US 1/SR 4 Bridge Replacement Over Altamaha River, Overflow 1 and Williams Creek

BR000-0001-00(216), P.I. No. 0001216
Appling and Toombs Counties, Georgia

Value Engineering Study Report

February 2010

BRIDGE #2 (OVERFLOW #1)
PLAN & ELEVATION
(Length = 300ft)

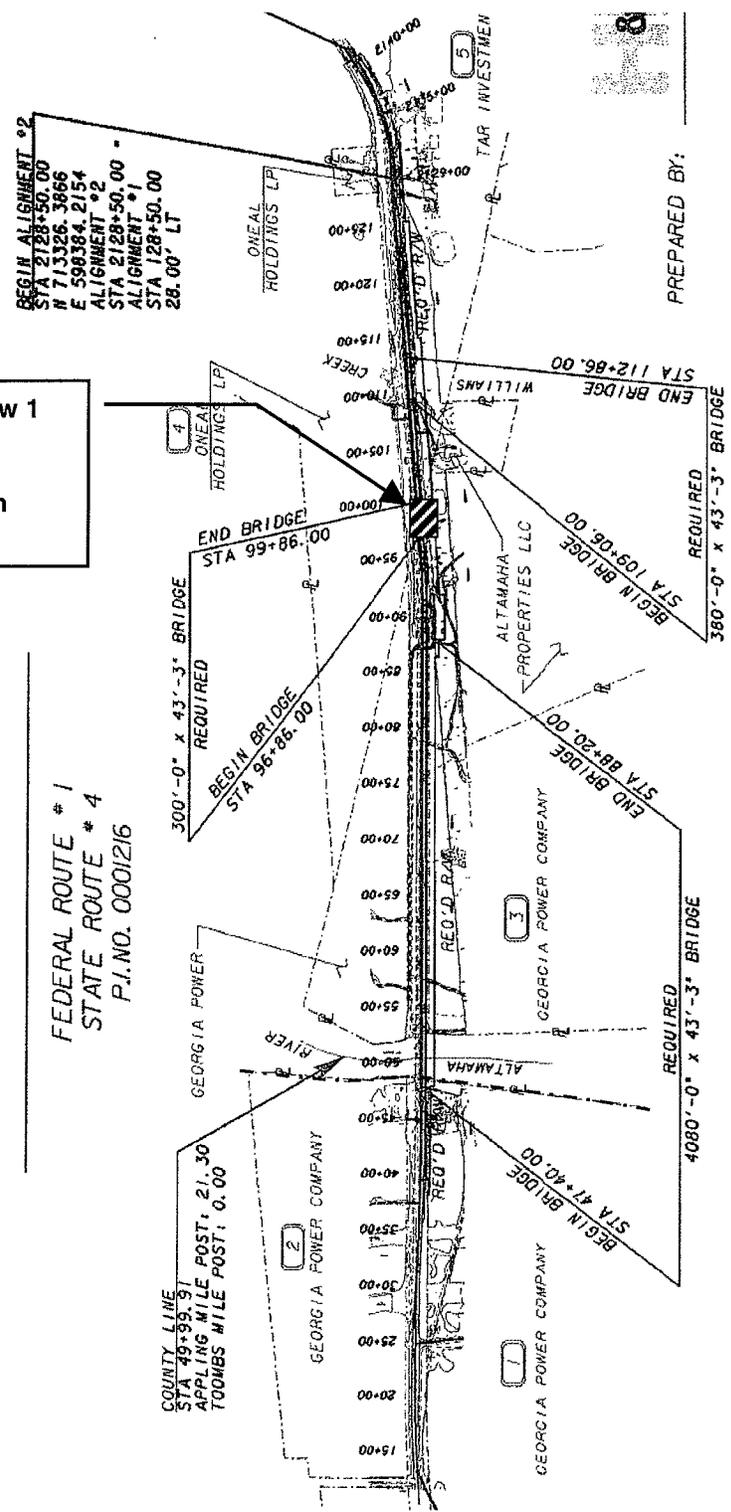
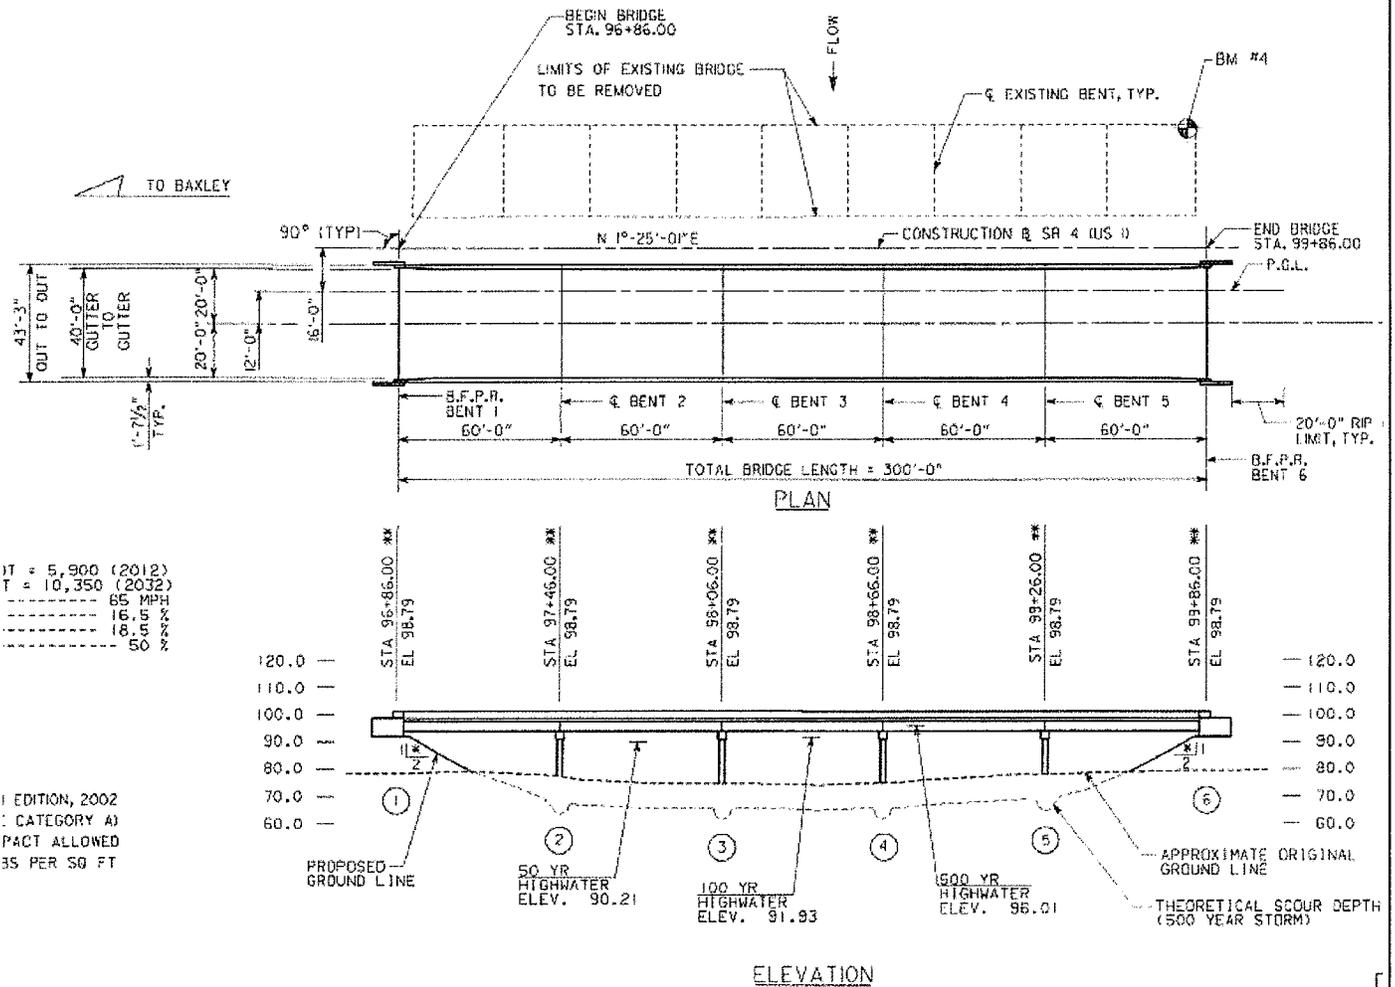
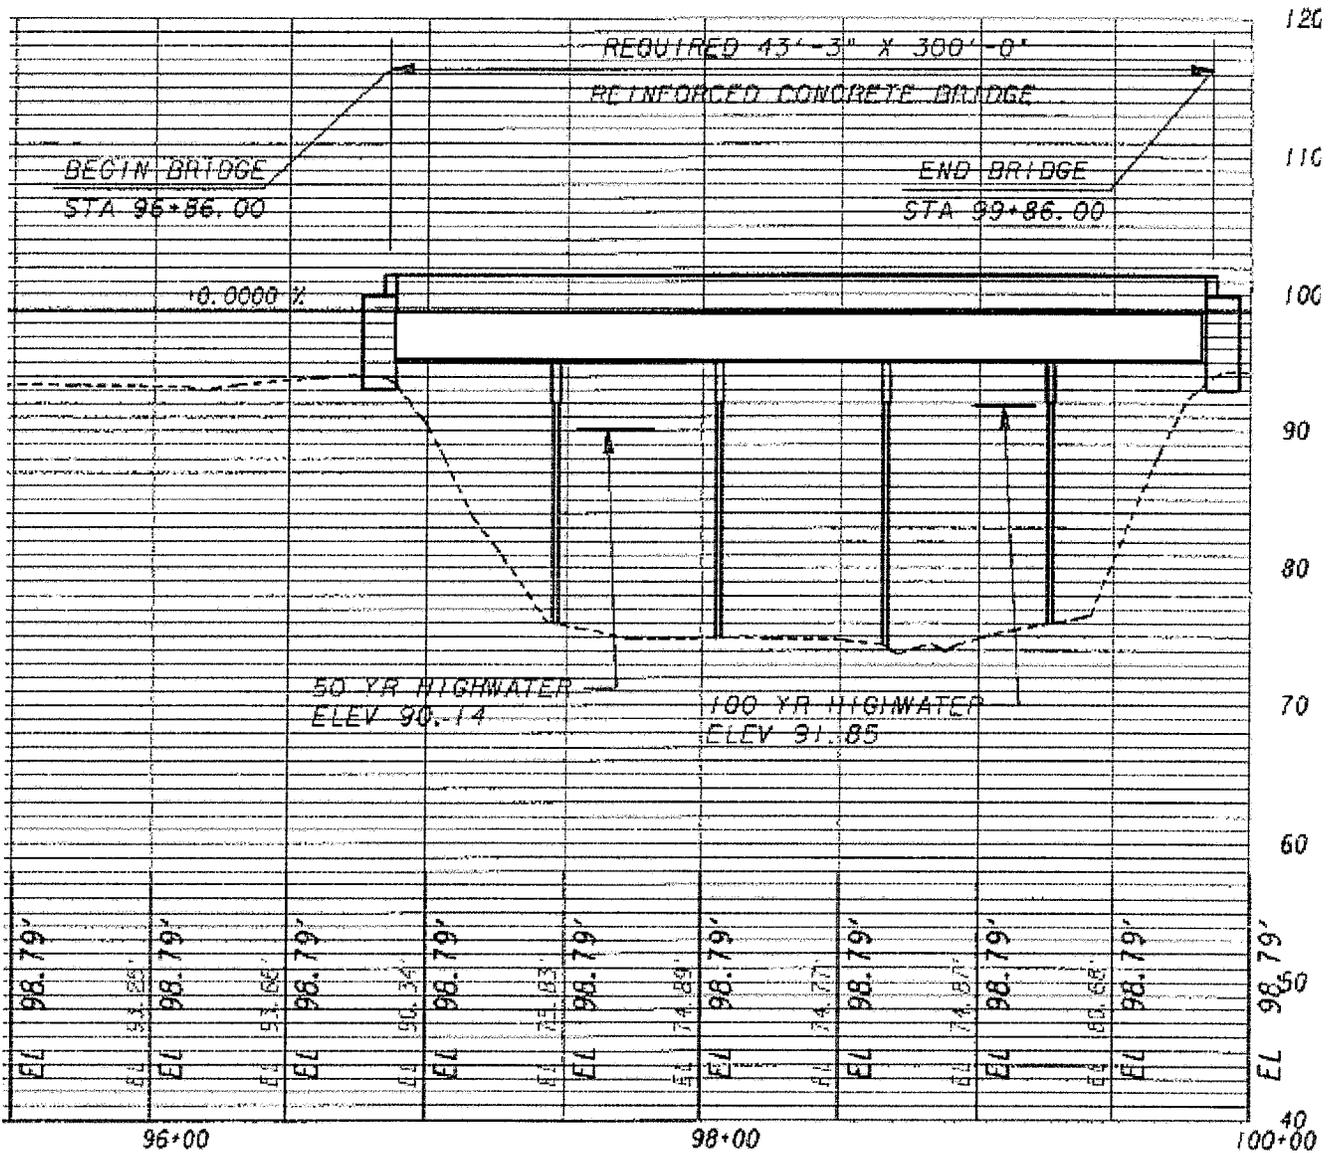
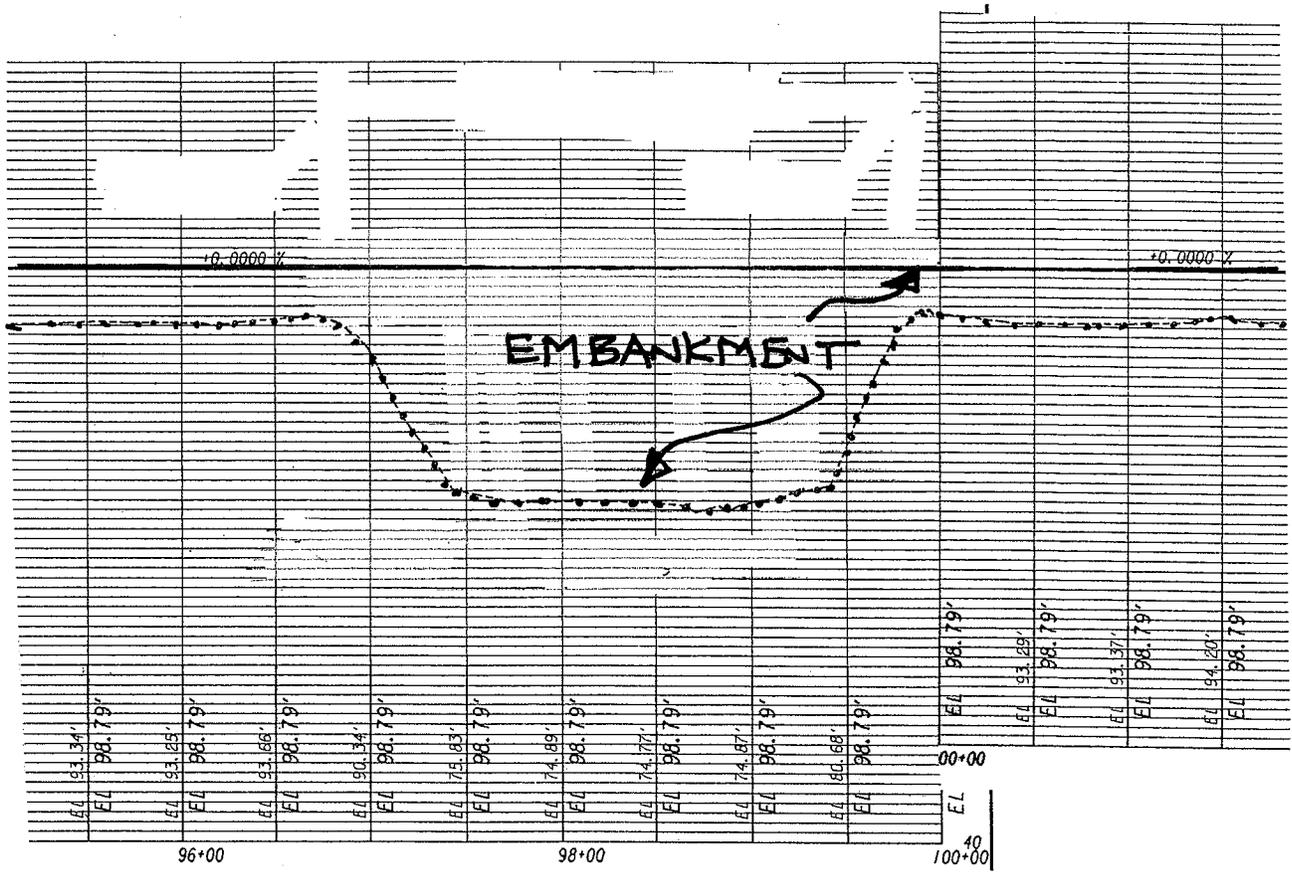
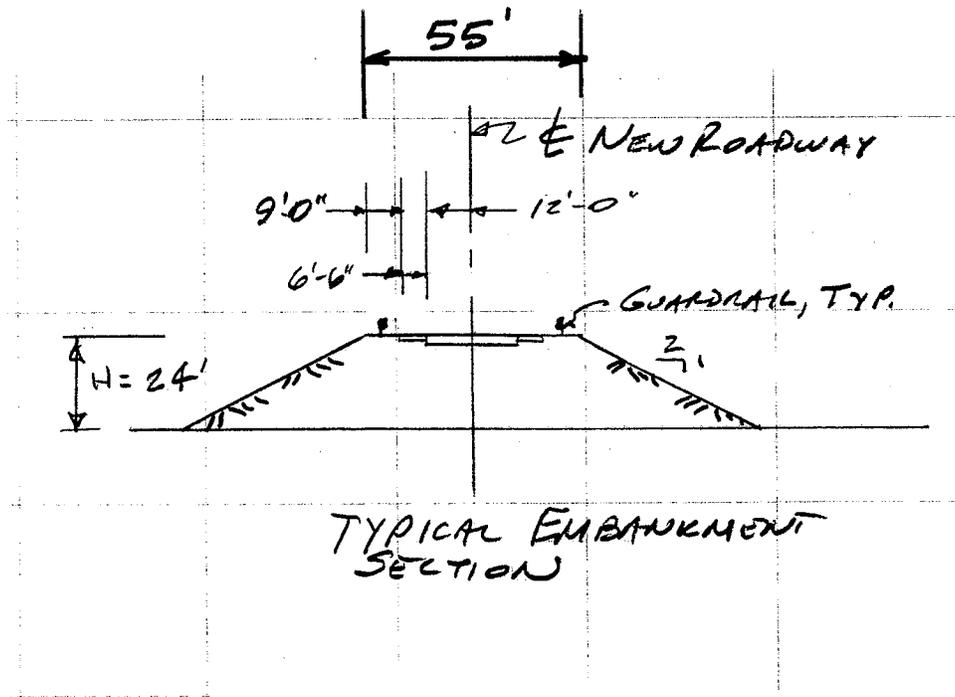
Eliminate the 300-ft.-long Bridge #2 at Overflow #1 and replace it with an embankment roadway section. A guide bank may be needed to protect the embankment and route the flow either to the Altamaha River or Williams Creek. Some mitigation or added right-of-way may also be required if a guide bank is needed.

BRIDGE #3 (WILLIAMS CREEK)
PLAN & ELEVATION
(Length = 380ft)

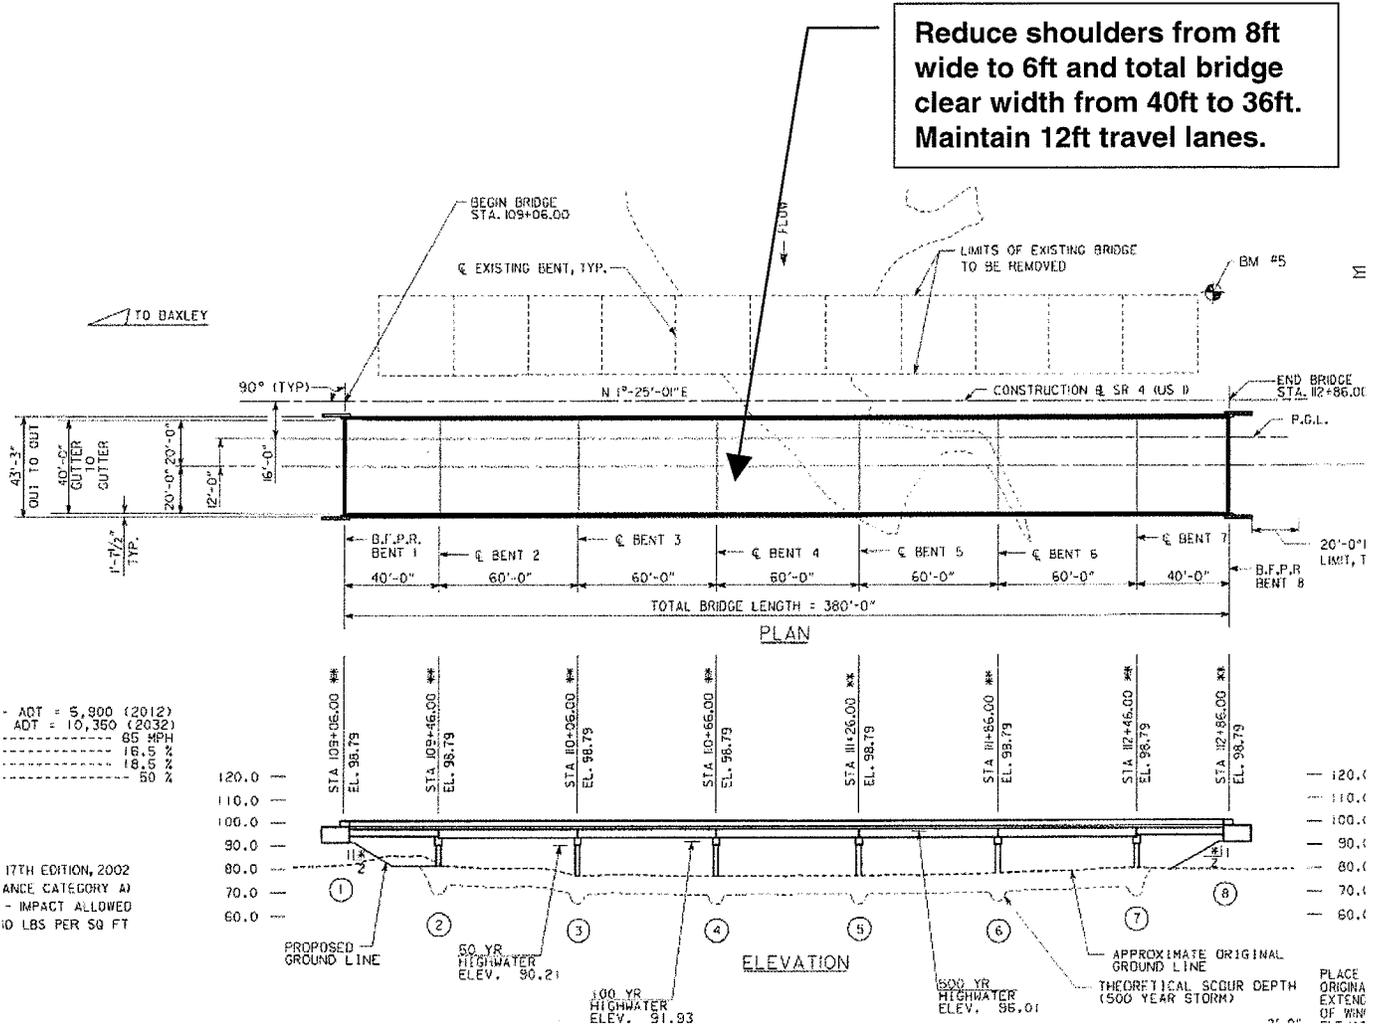
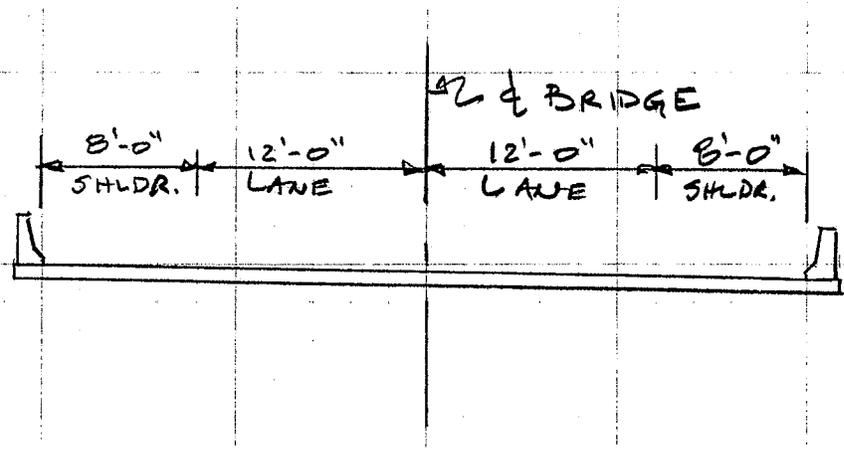
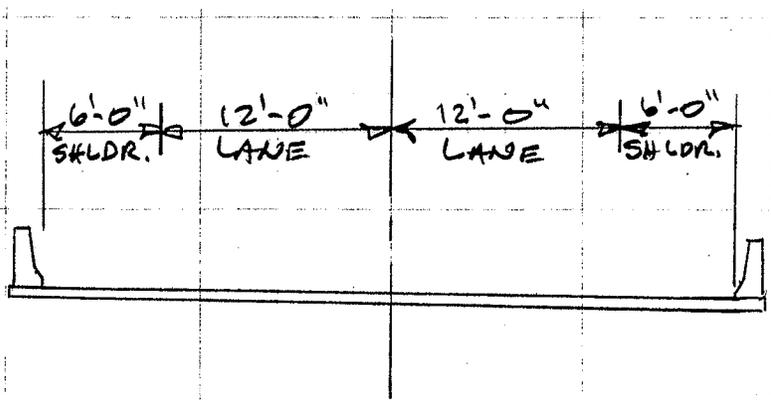
The GDOT Bridge and Structures Design Policy Manual calls for gutter-to-gutter widths of 40 ft. for two-lane state routes with ADT over 2,000, and 36 ft. for multilane divided state routes with ADT over 2,000. While this route will have only two lanes when construction is finished, in the future it will be widened to a 4-lane section since this is a GRIP corridor. Since the bridges make up nearly half the length of this project, reducing the bridge width will greatly reduce construction material and labor requirements.
